Planning Commission Meeting 700 Doug Davis Drive Hapeville, Georgia 30354

October 8, 2019 AGENDA 6:00 pm

3.II. O Porsche Avenue Site Plan Review

RE: Site Plan Review – Porsche Avenue Service Center

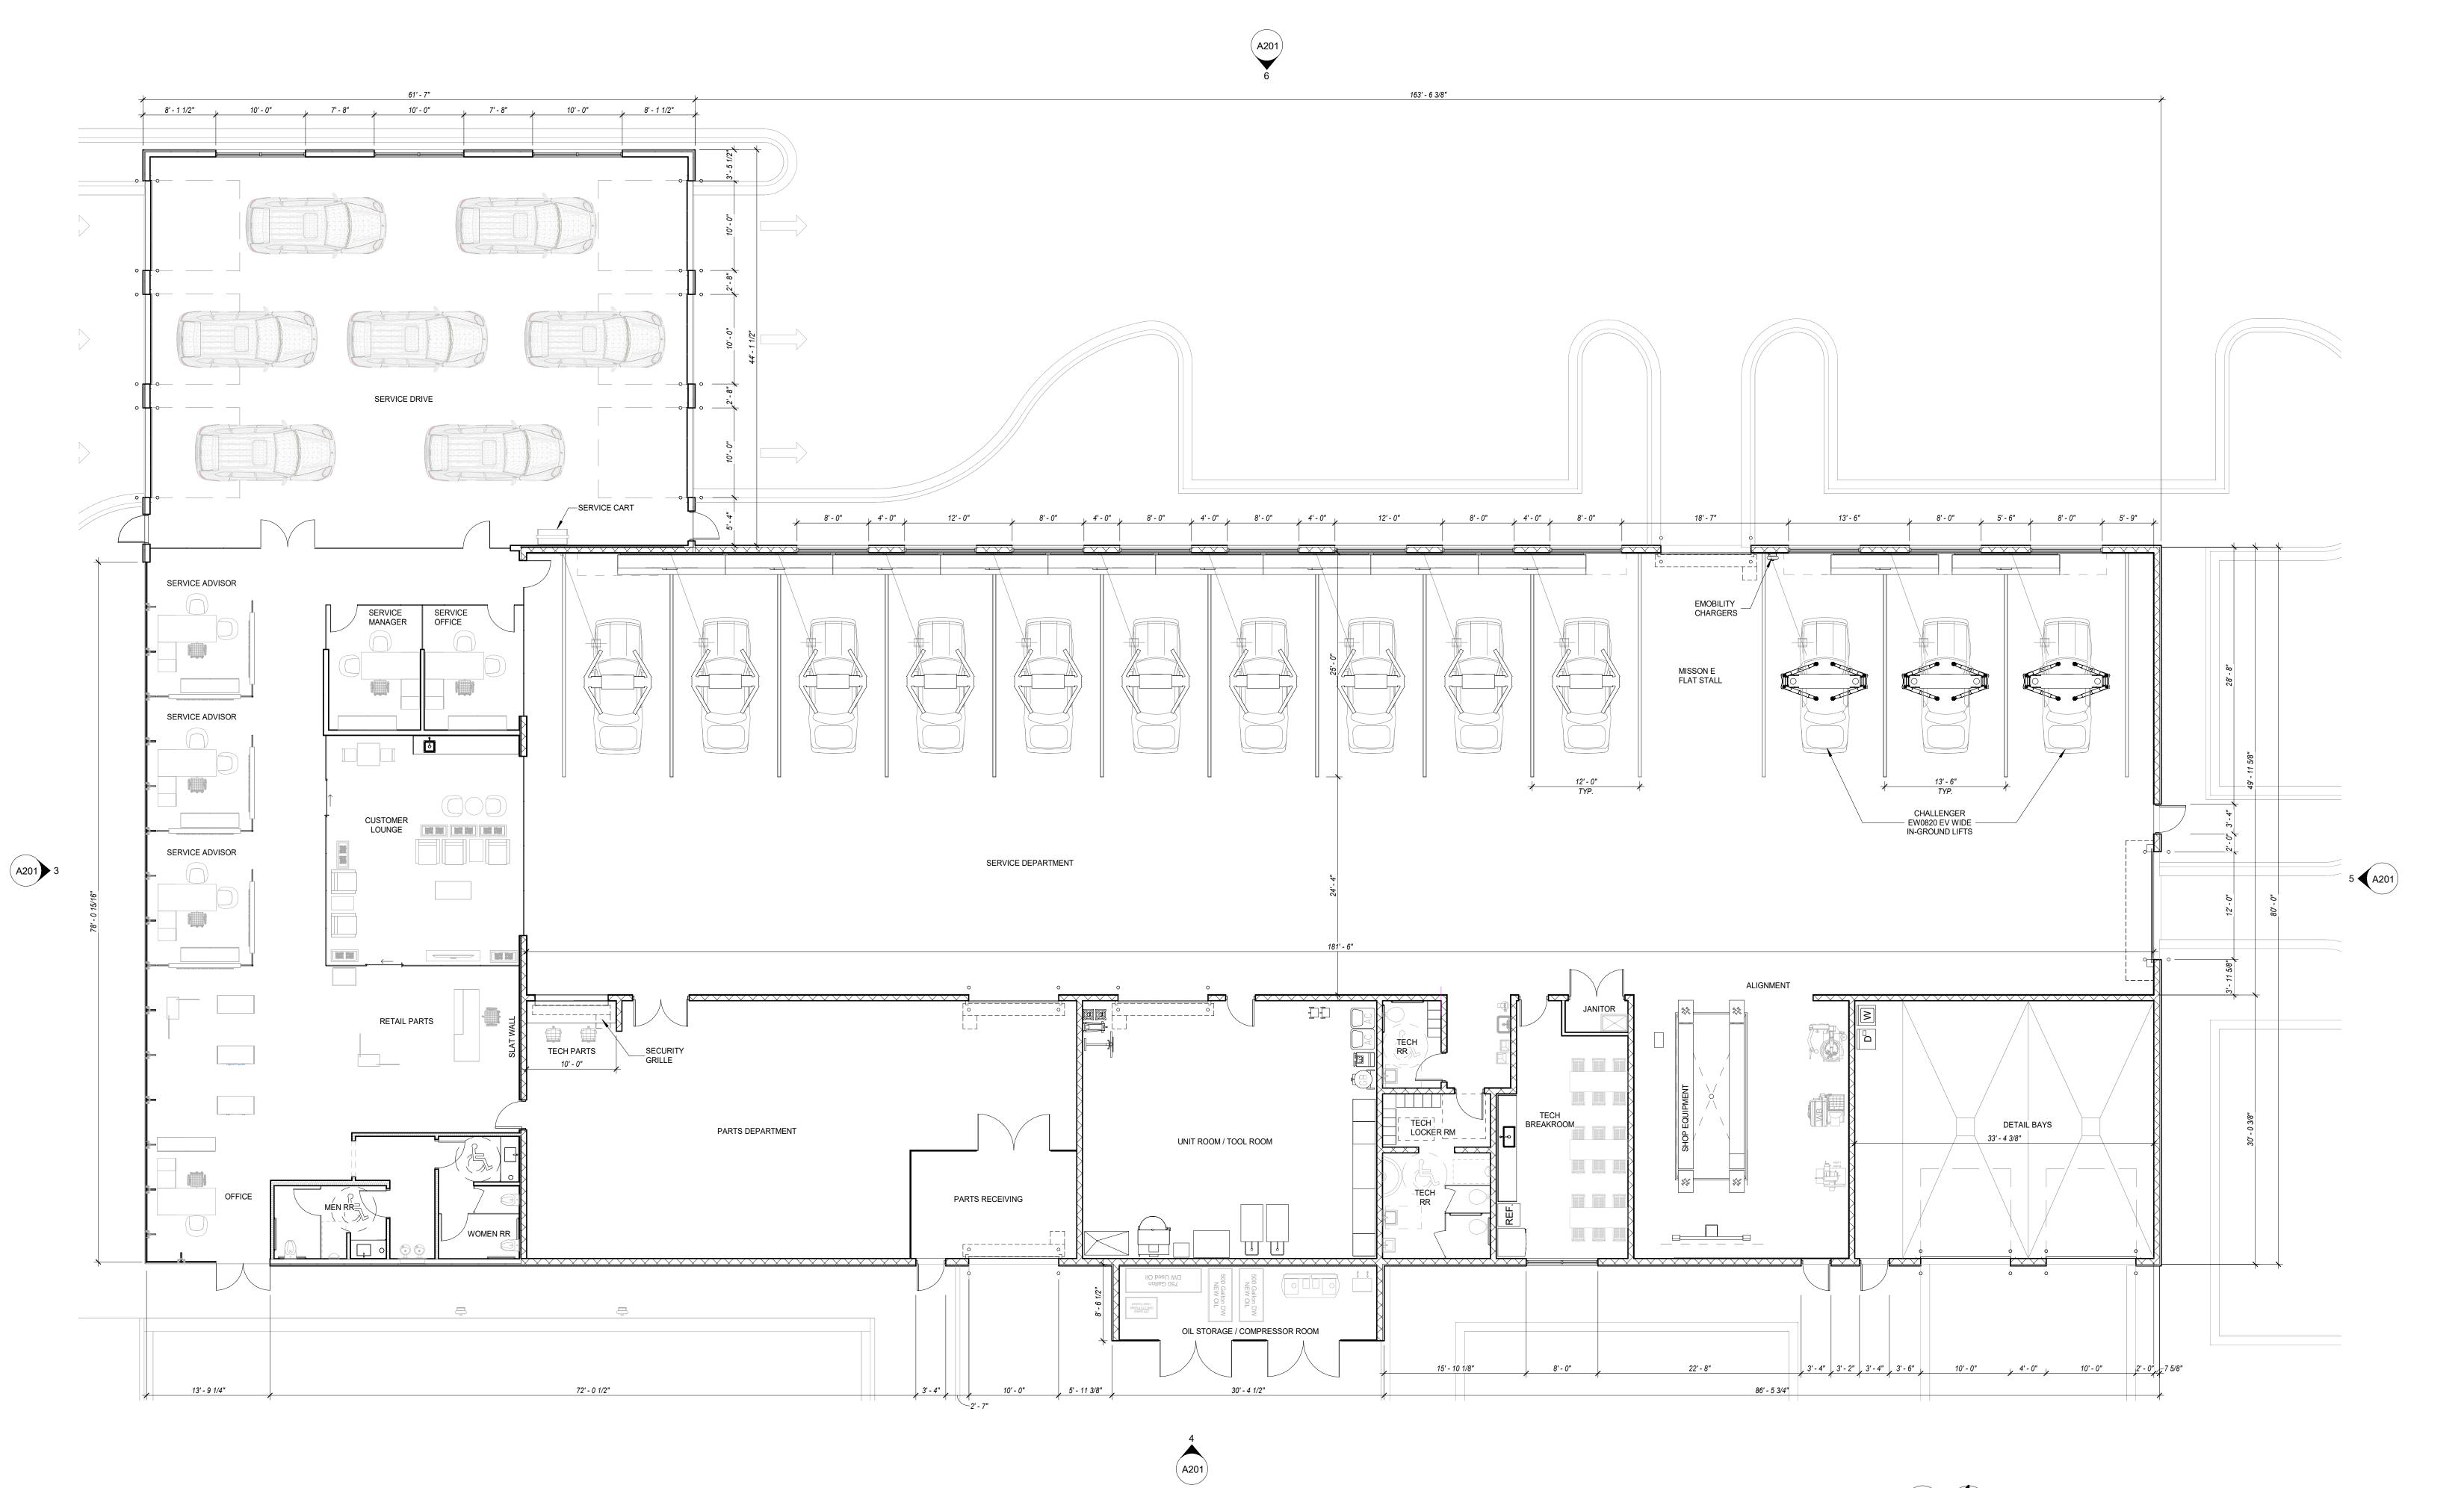
- 1. All drawings should be sealed by the design professional of record.
- 2. The exterior wall material of the proposed building is not described to verify compliance with Section 93-18-5(3) regarding wall material composition for the indicated B-P zoning district.

- 4. A local "on-site" project benchmark tied to mean sea level datum should be included on the plans.
- 5. The distance from the building front facing Porsche Avenue to the right of way of Porsche Avenue or a similar dimension to establish the front building line should be shown.

- 24. The proposed site plan shows site improvements and the building located over existing 12 inch and 2 inch water mains and storm drain pipes. The plans do not show how these existing features will be handled with the proposed site improvements.
